This Service Bulletin replaces bulletin, "Pilot Bearing", PV729-FSB412-003\_M (USA45504) dated (11/2010).

CHU, CXU, GU, TD, MRU, CTP, CXP

MP7, MP8, MP10

## FSB 412-003, Pilot Bearing

W4062022

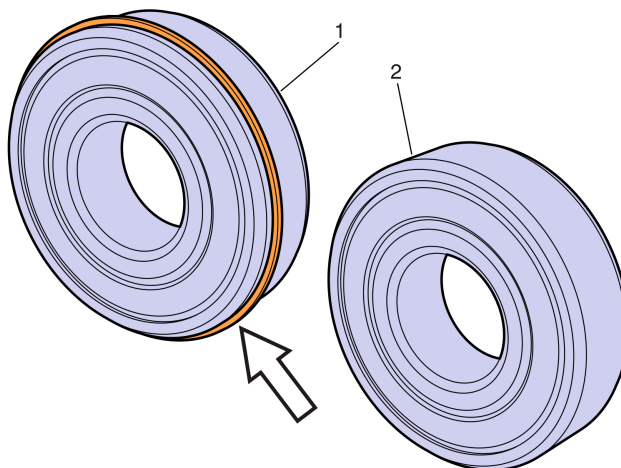
The pilot bearings (part number 25100046) used on all Mack legacy engines from the E6 through the ASET engine families have an external snap ring which fits into a recessed area of the flywheel. The new MP engine family does not have this recessed area in the flywheel and requires a new pilot bearing (20512915) which does not have the external snap ring.

If the incorrect pilot bearing (with external snap ring) is used in an MP engine flywheel, the additional thickness of the snap ring will move the crankshaft forward into the engine block resulting in zero clearance at the crankshaft thrust washer area. Continuous operation without clearance will cause the crankshaft thrust washers to fail prematurely and progressively damage the crankshaft and engine block.

Extreme caution should be taken when using aftermarket pilot bearings, especially if the flywheel does not require a pilot bearing with an external snap ring. The external snap ring should be removed before installation.

No snap ring is required on the new pilot bearing for Mack MP series engines. Failure to replace pilot bearings with the correct part number for Mack MP engines will result in severe engine damage.
